**TO:** Jamie Donaldson, Planner II  
Community Development Department

**FROM:** Laurel Christian, Planner II  
Public Works Department

**DATE:** May 5, 2023

**SUBJECT: PUBLIC WORKS RECOMMENDATIONS  
SUB-UGA-SPR-ADJ-TRV-DR23-02 (22-119071)  
2100 BLOCK DOAKS FERRY ROAD NW  
6-LOT SUBDIVISION AND MULTI-FAMILY DEVELOPMENT**

**Exhibit a.** Street Alignment Exhibit

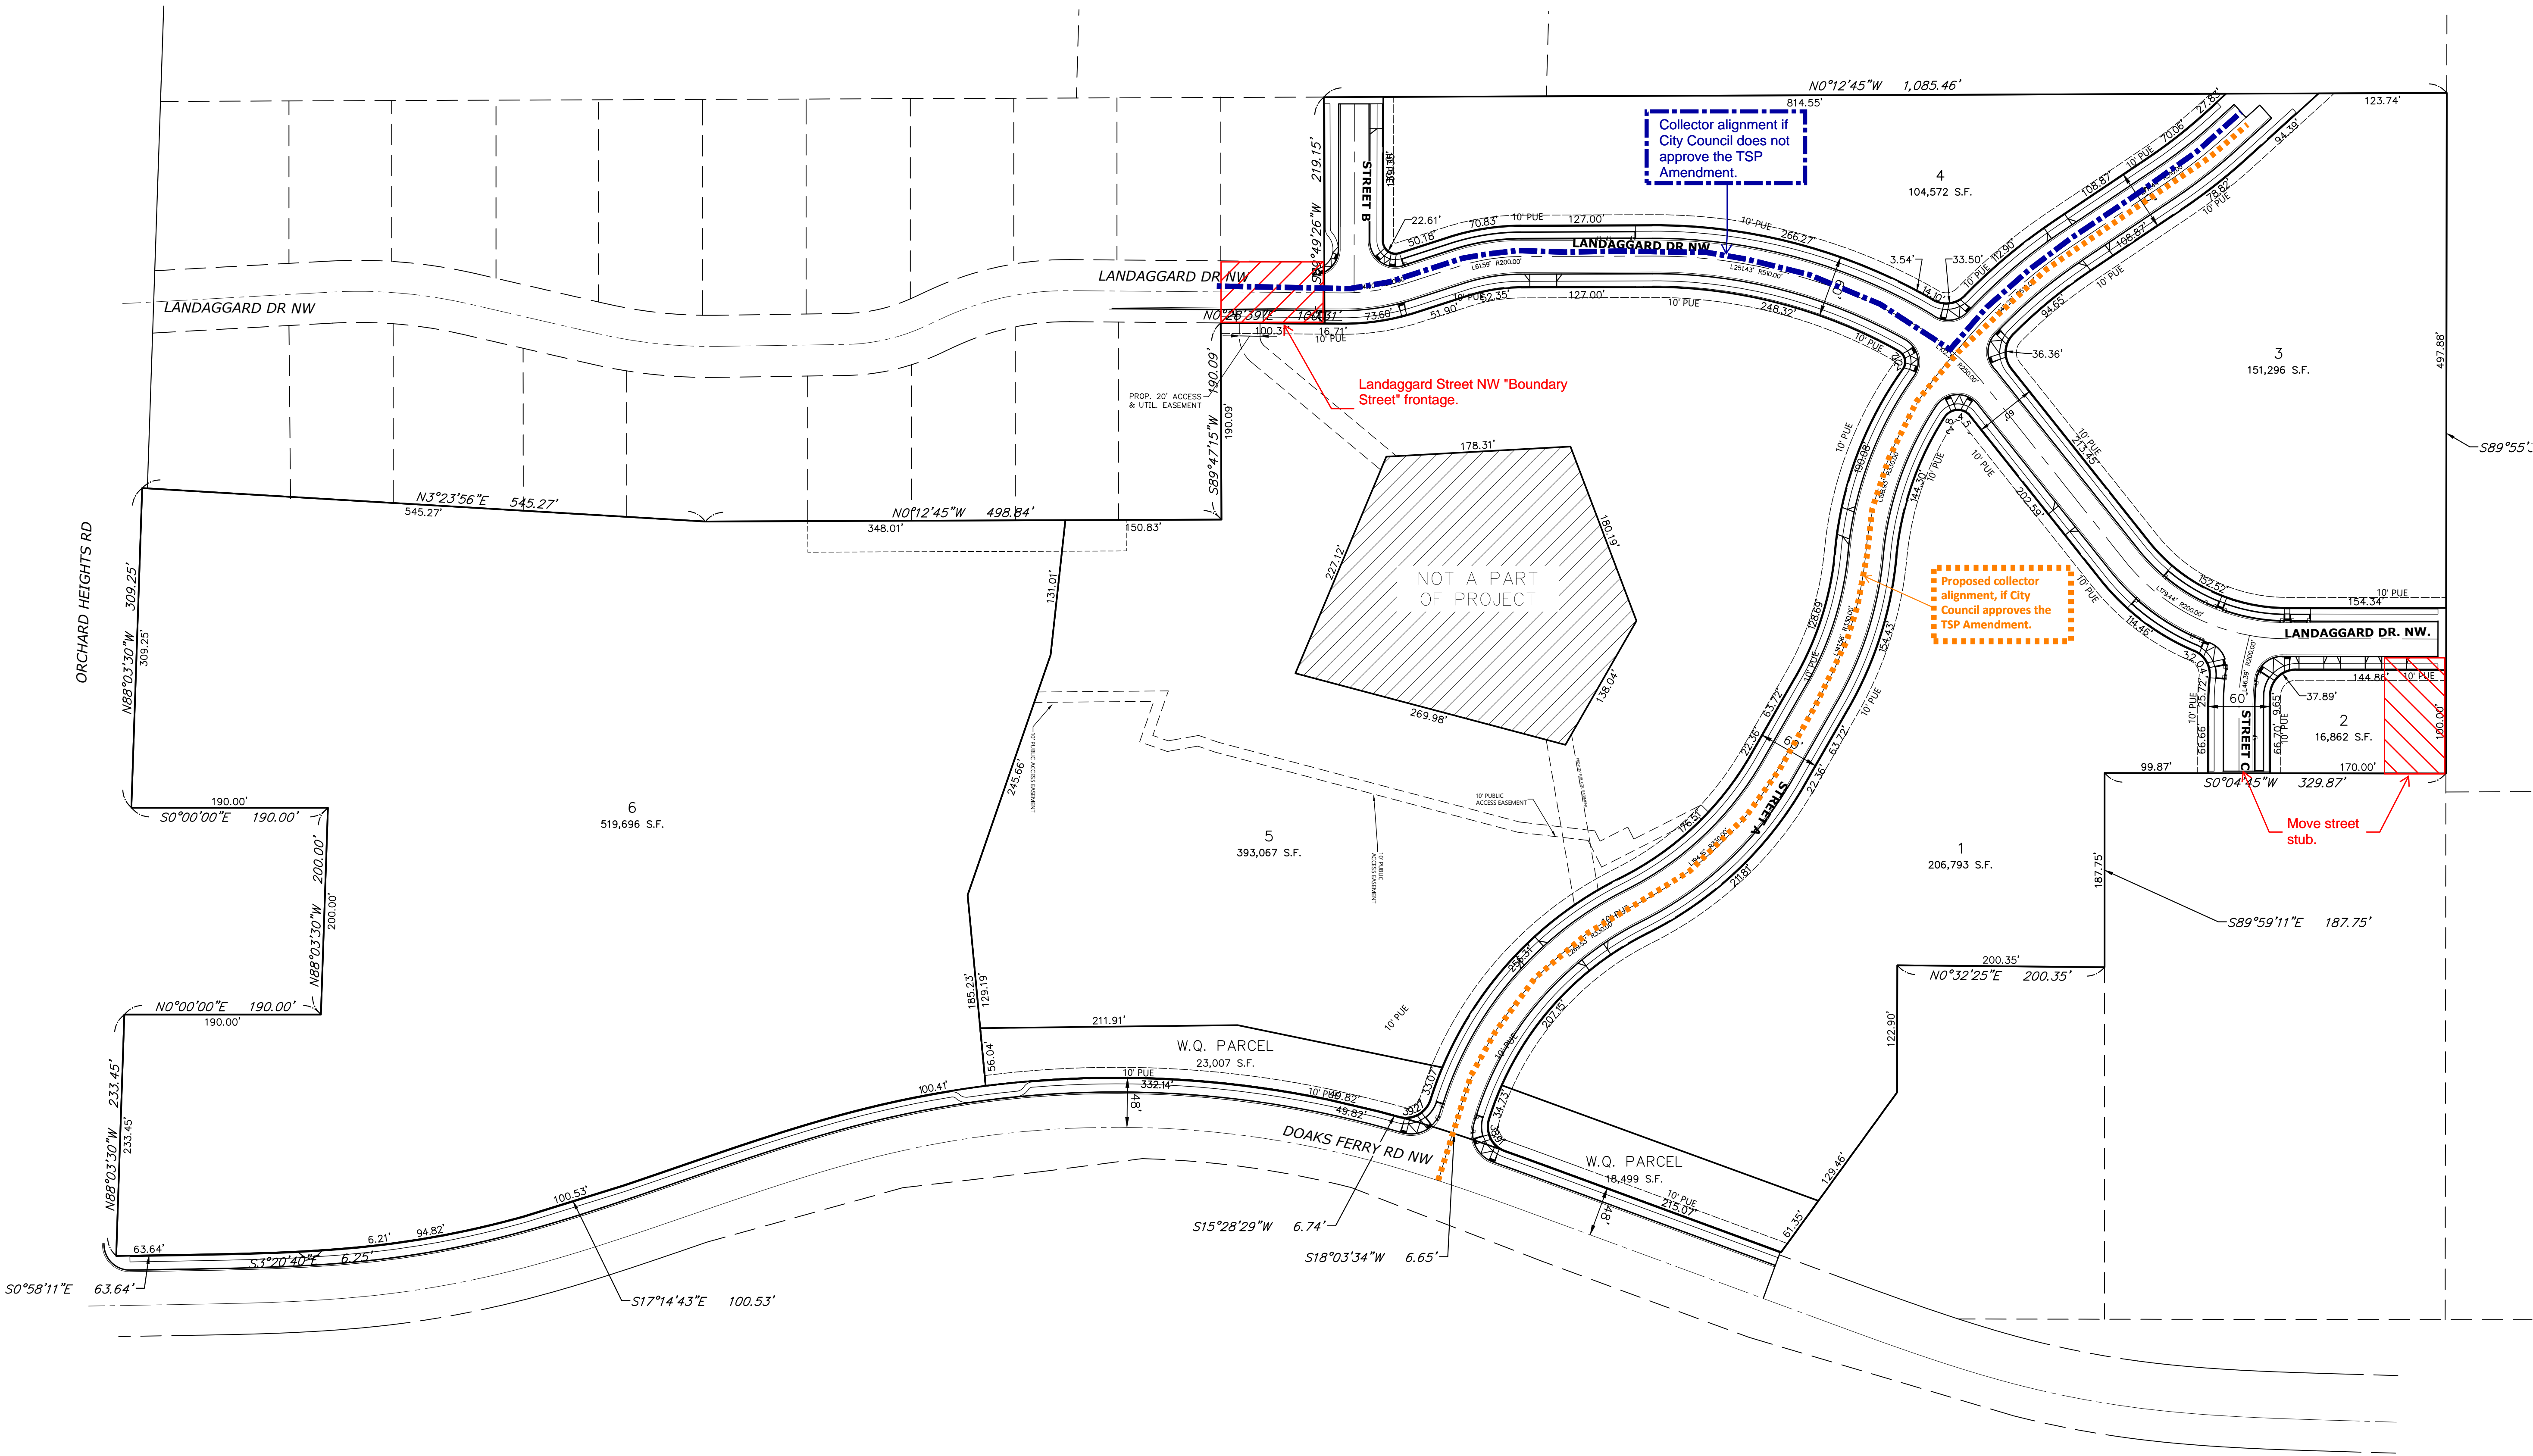
Pursuant to SRC 803.035(a), *local streets shall be extended to adjoining undeveloped properties for eventual connection with the existing street system*. The applicant's tentative plan shows Street C that stubs to neighboring property for an eventual connection to Doaks Ferry Road NW. This stub is required in order to provide for the 600-foot block spacing required under SRC 803.030(a) and meet street connectivity standards. The applicants location of proposed "Street C" conflicts with an existing dwelling and accessory structure located on Polk County Tax Lot No. 073W17B00300 (2217 Doaks Ferry Road NW) while there is undeveloped property northly that the street can be stubbed to (Polk County Taxlot No. 073W17B00200). Staff recommends the proposed street stub be moved to the north to avoid conflicts with the existing structures as shown in **Exhibit a**.

The subject property has approximately 100 feet of frontage on the existing Landaggard Drive NW right-of-way as shown on **Exhibit a**. This portion of Landaggard Drive NW does not meet local street standards according to the Salem TSP. The applicant shall be required to construct a three-quarter street boundary street improvement along the existing Landaggard Drive NW frontage. If City Council does not approve the requested Transportation System Plan Amendment (22-121104-GP), the boundary street improvement shall be constructed to "Collector Street B" standards.

**Condition:** Modify the proposed "Street C" stub street location to the north line of proposed Lot 2 to avoid conflicts with existing structures on neighboring property not included in the development proposal.
